Report No. 10CFR21-0124
 Rev. 0: 03/21/19

**10CFR21 REPORTING OF DEFECTS
 AND NON-COMPLIANCE**

COMPONENT: Excitation Transformers for Vickers Voltage Regulator System

SYSTEM: Emergency Diesel Generator – Voltage Regulator System

Figure 2: EPT Outline Drawing

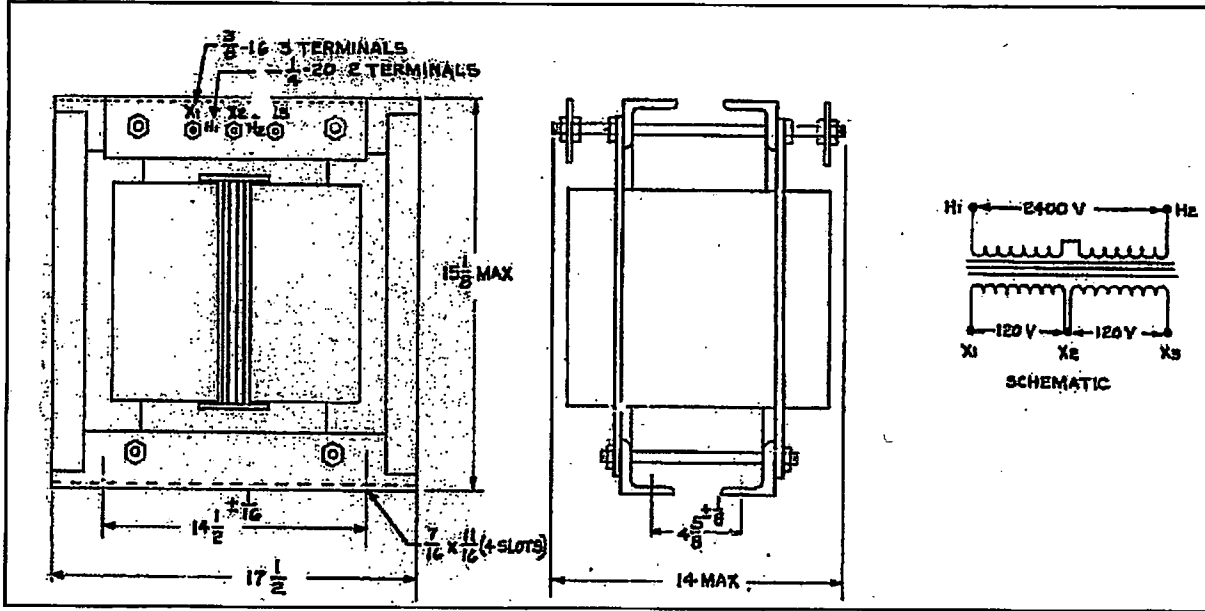
Three single-phase EPTs are wye connected on the primary and delta connected on the secondary. Per the system design, EPT primary H1 should have the same polarity of EPT secondary X1. Contrary to this requirement, EPT primary H1 has the same polarity as secondary X3.

Return to ESI for rework to have EPT primary terminal markings (H1 & H2) re-labeled.

Figure 3: PCT Outline Drawing

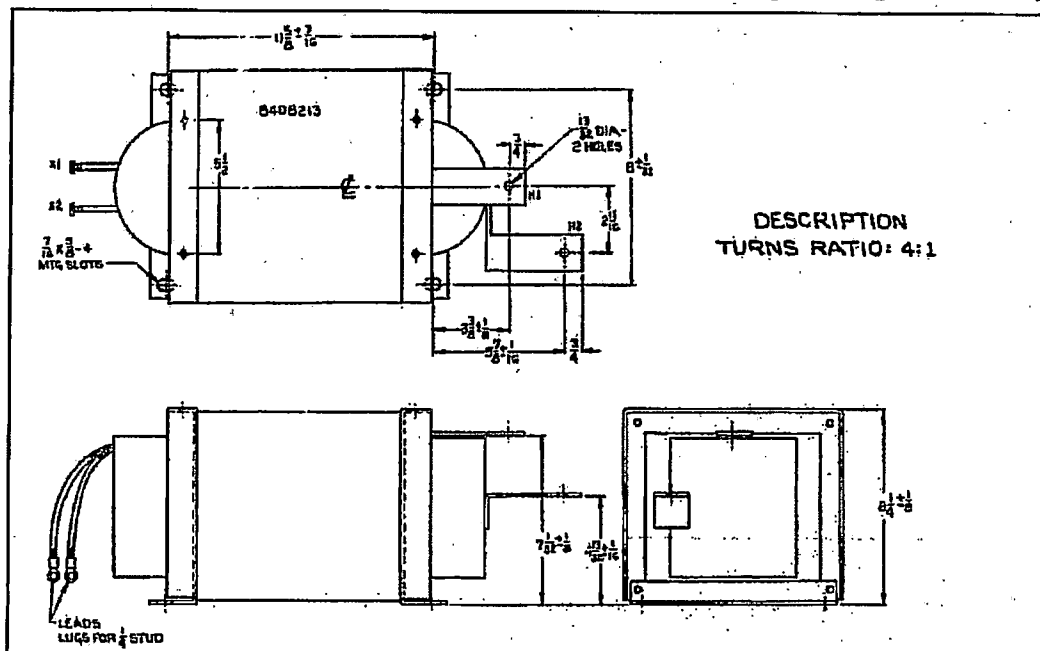
Three single-phase PCTs provide a secondary voltage proportional to the primary current. The PCT, in conjunction with the EPT, provide the power to support generator field excitation. Certain characteristics of the PCT secondary voltage are determined by the magnitude of an air gap in the core construction. It has been determined the PCT supplied by ESI has a gap of 0.030" whereas the original design PCT has a gap of 0.080".

Return to ESI for rework. The PCT requires additional insulating material to increase the core gap.

Figure 4: Reactor Outline Drawing

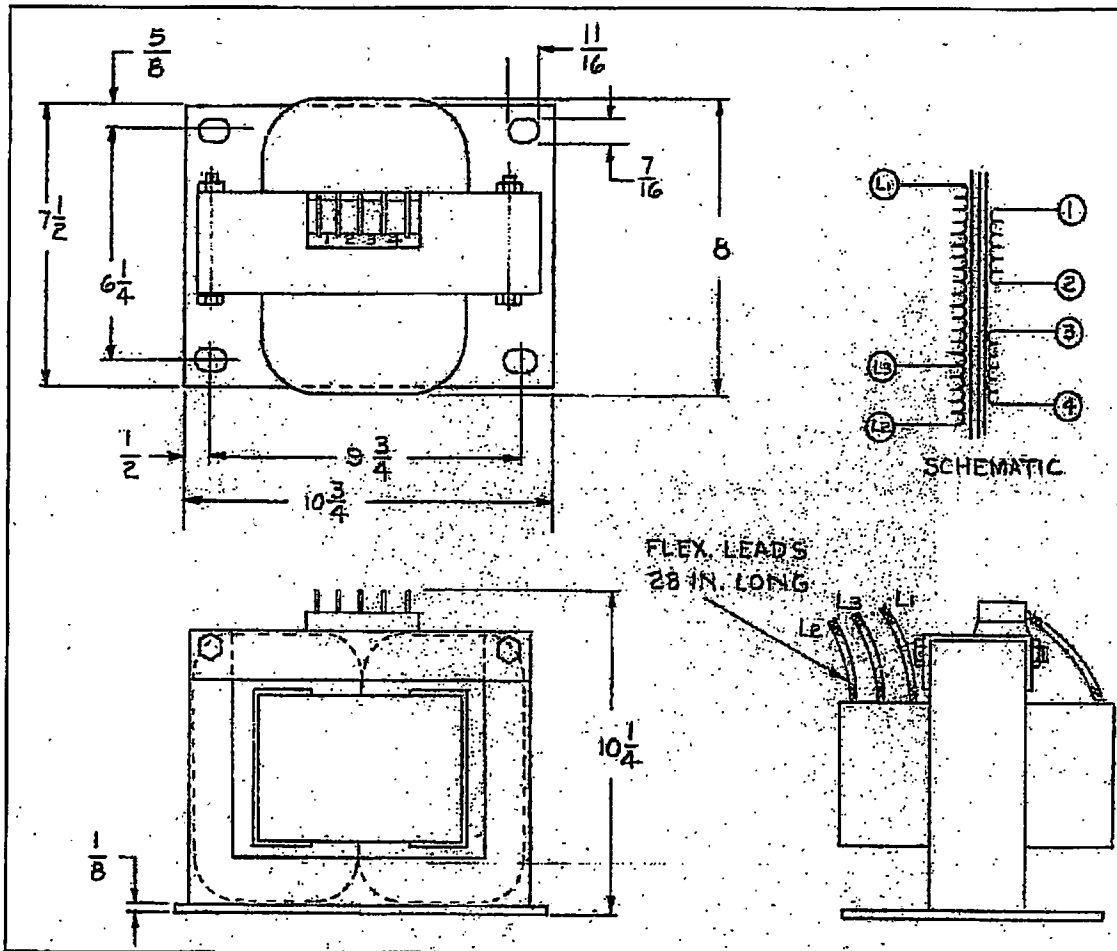
In conjunction with a rectifier diode, the saturable reactor acts as a magnetic amplifier. Six of these magnetic amplifier assemblies are used in the rectifier bridge of the voltage regulator system. The reactor receives a bias and control current from the voltage regulator which varies the level of saturation in the reactor core. As the level of saturation changes, the reactor impedance varies which increases or decreases generator field voltage. It has been determined the saturable reactor supplied by ESI has coil winding and core winding differences from the originally supplied reactor that may cause subtle, but undesired performance differences.

Return to ESI for replacement.
